ITEM FOR ENVIRONMENTAL COMMISSION AGENDA

NAME & NUMBER OF PROJECT: Crossroads Logistics Center Additions (SP-2021-0169D)

REQUEST: Variance request is as follows:
Request to vary from LDC 25-8-342 to allow fill over 4feet up to 17feet

Project Name: Crossroads Logistics Center Additions
Ordinance Standard: Watershed Protection Ordinance
Variance Request: **To allow for fill exceeding 4 feet up to 17 feet for building construction**

CROSSROADS LOGISTICS CENTER ADDITIONS
CUT AND FILL EXHIBIT
8508 E. PARMER LANE
AUSTIN, TEXAS 78653

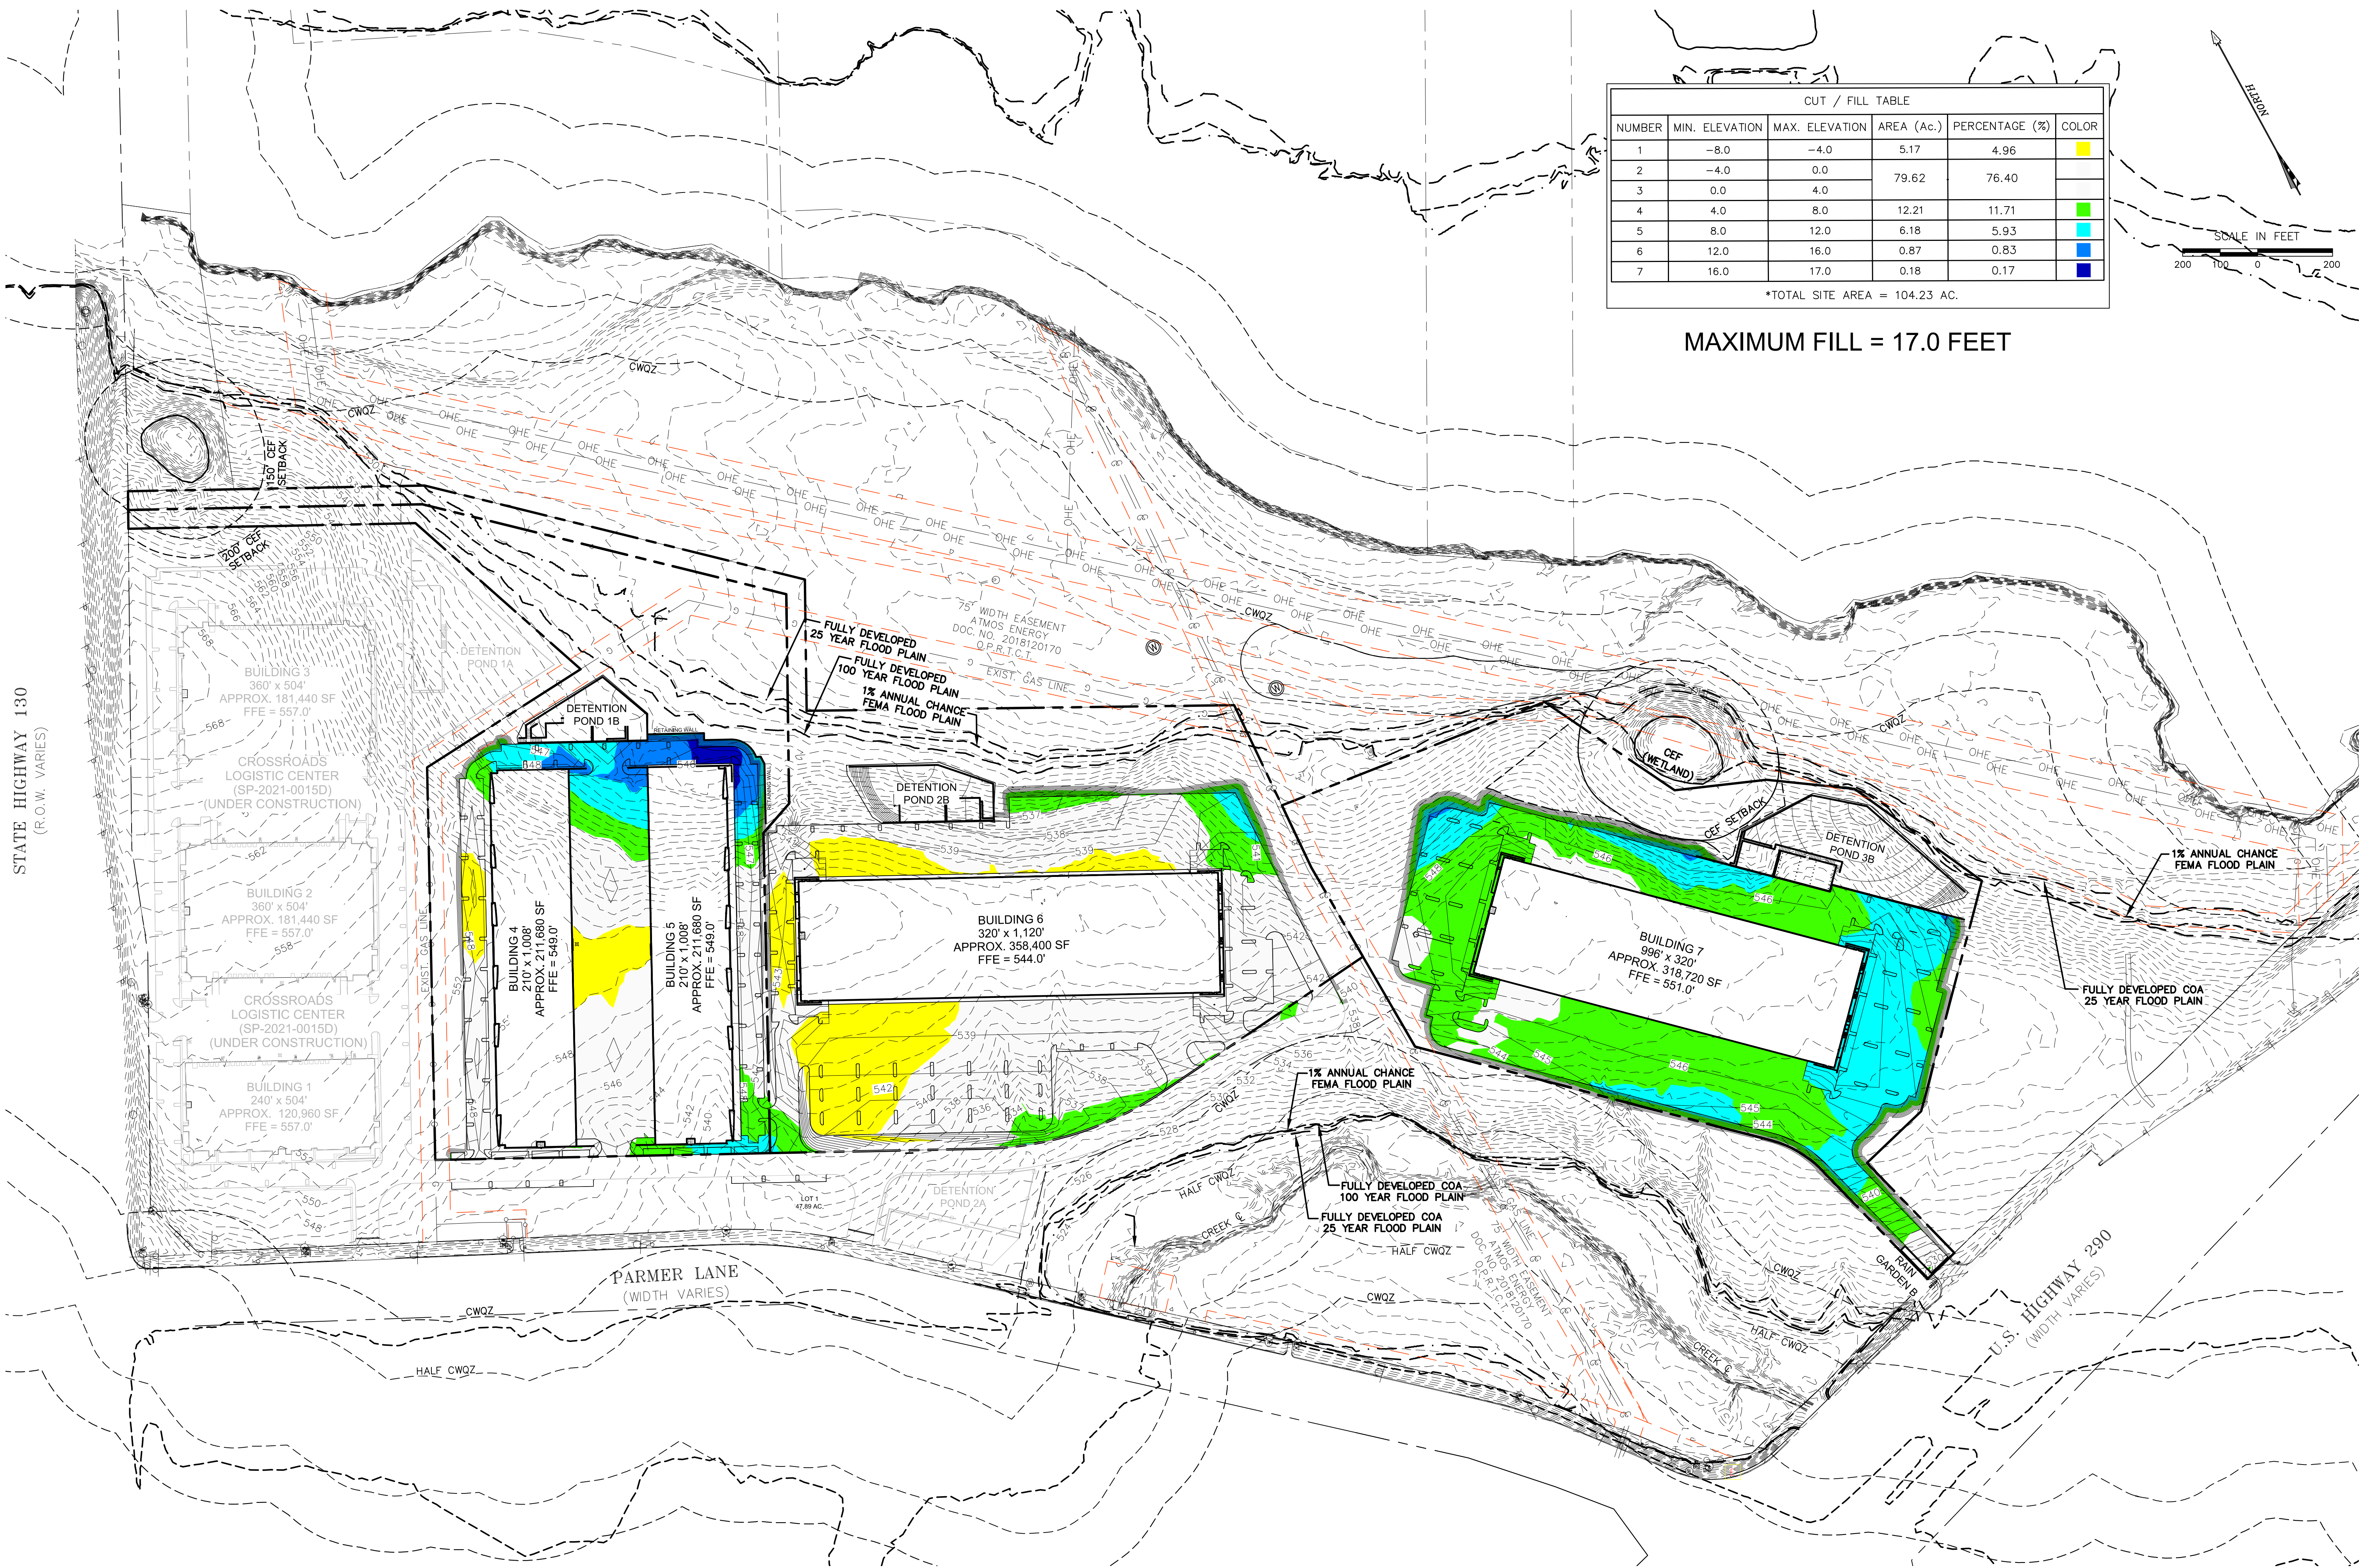
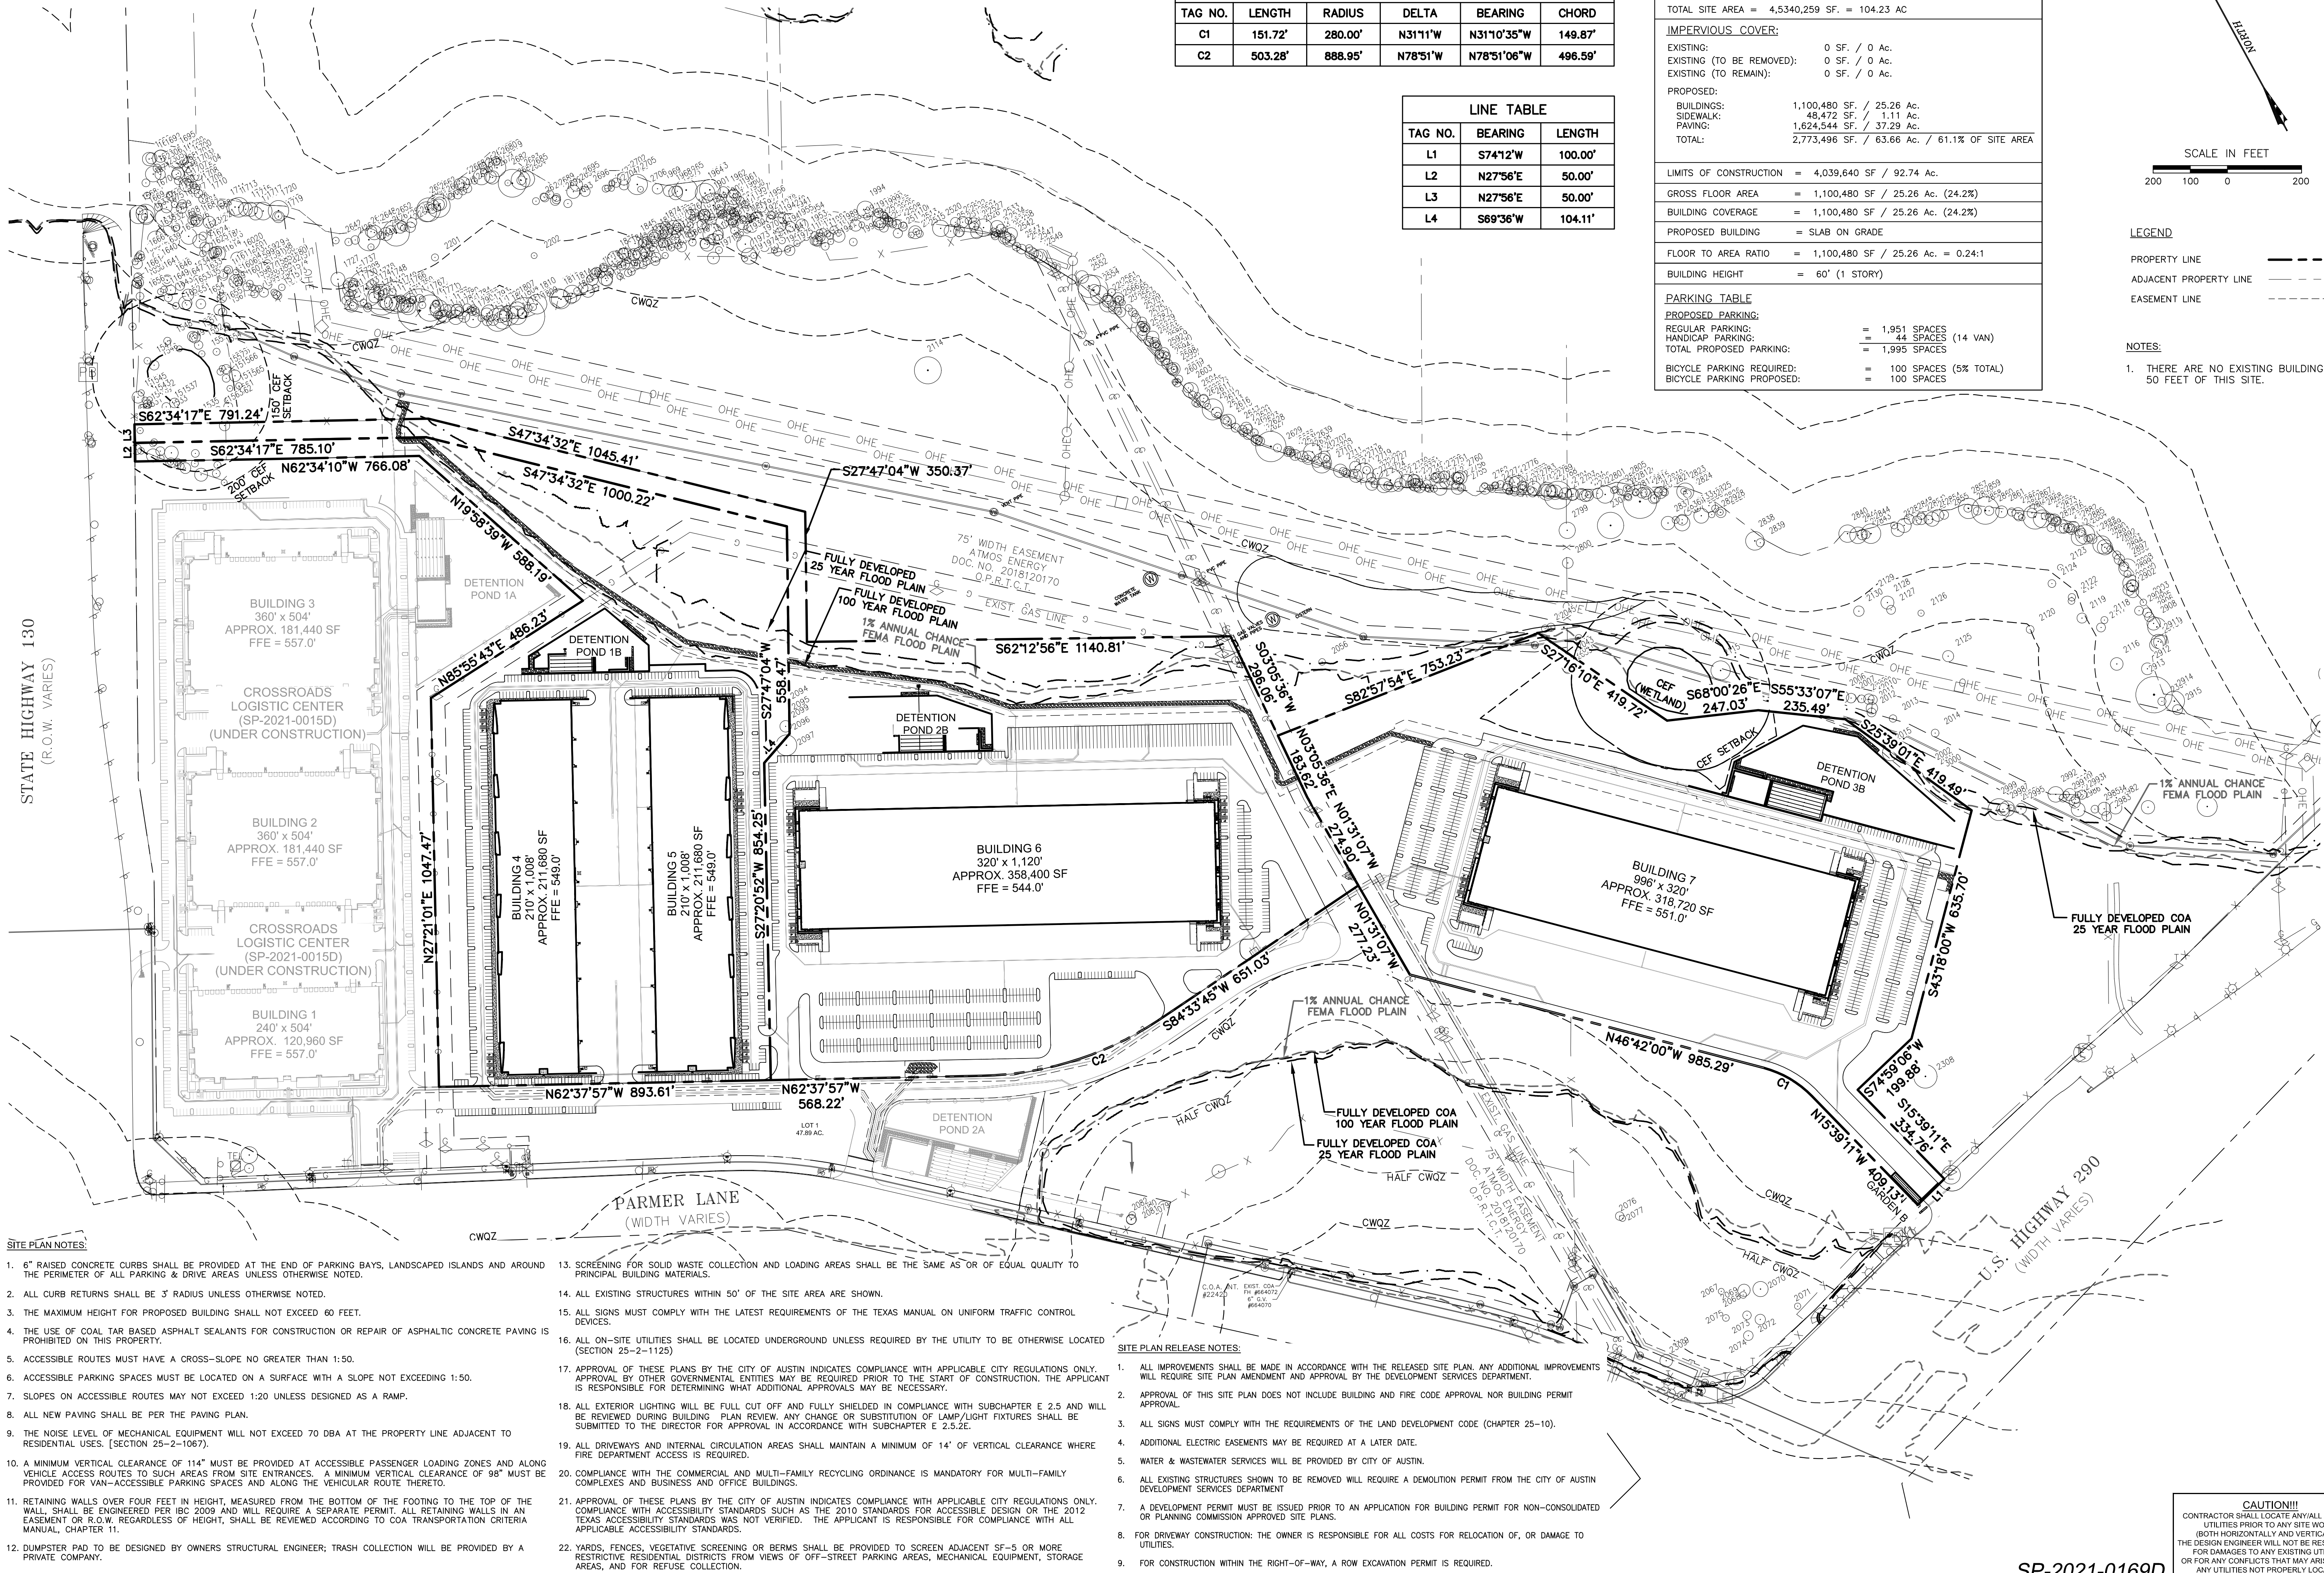
The limits of the fill do extend beyond the building as shown in the cut/fill exhibit but is contained with a retaining wall structure designed in conjunction with the building walls, so the building is supported. Prior projects in this industrial development zone had a similar situation. A prime example is Park 183 Buildings 6 & 7, SP-2021-0072C. A Land Use Commission variance was granted to LDC 25-8-342 to allow cut and fill up to 17 feet.

- Increase setback area by a minimum of 1.09acre for existing CEF.
- Preserve trees/natural areas.
- Apply City of Austin Landscaping Ordinance on ETJ site.
- Increase tree inches on site/mitigation.
- Provide structural containment of fill with a retaining wall.
